- 2 different pairs of differential vias: BC2 (left) and BCREf (right)
- They seem exactly the same: going from TOP to the Bottom and connecting signals from the Top to the L3

- This is the VIA extracted for BC2

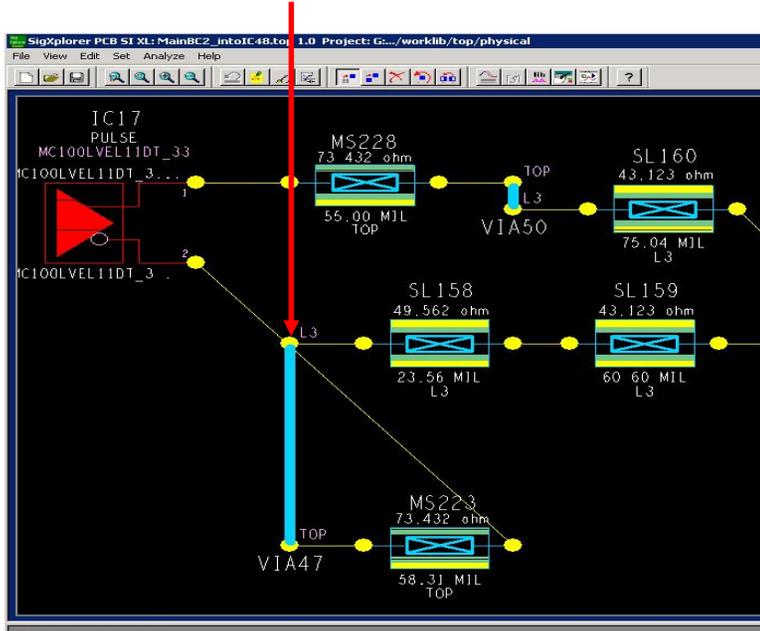
Why the extracted vias are looking different ?!

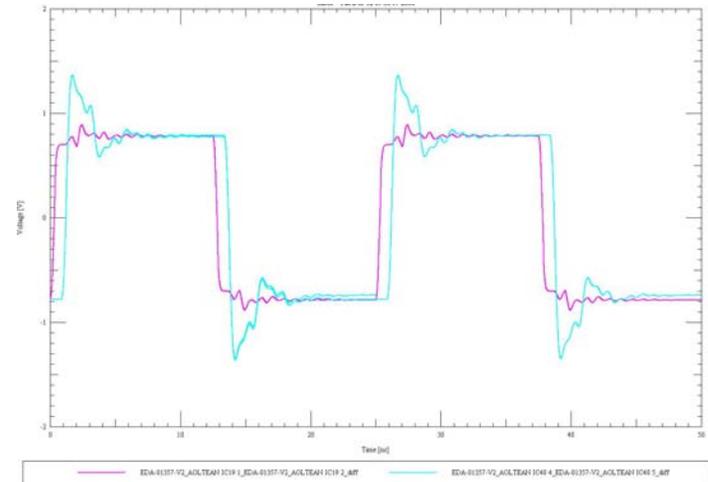
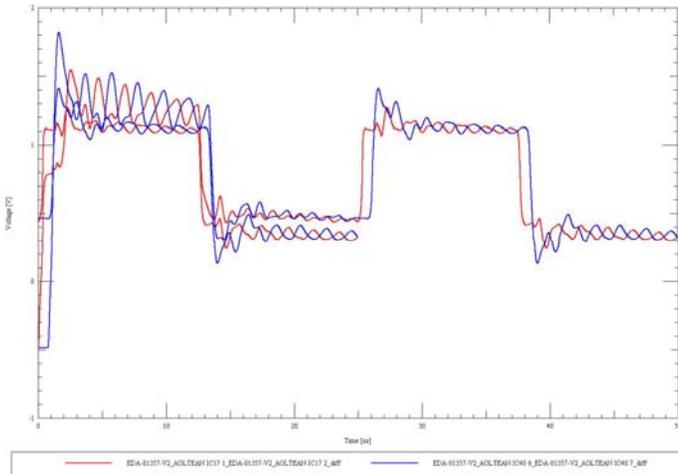
The signals for BC2 are looking as well different (and bad!) compared to BCREF
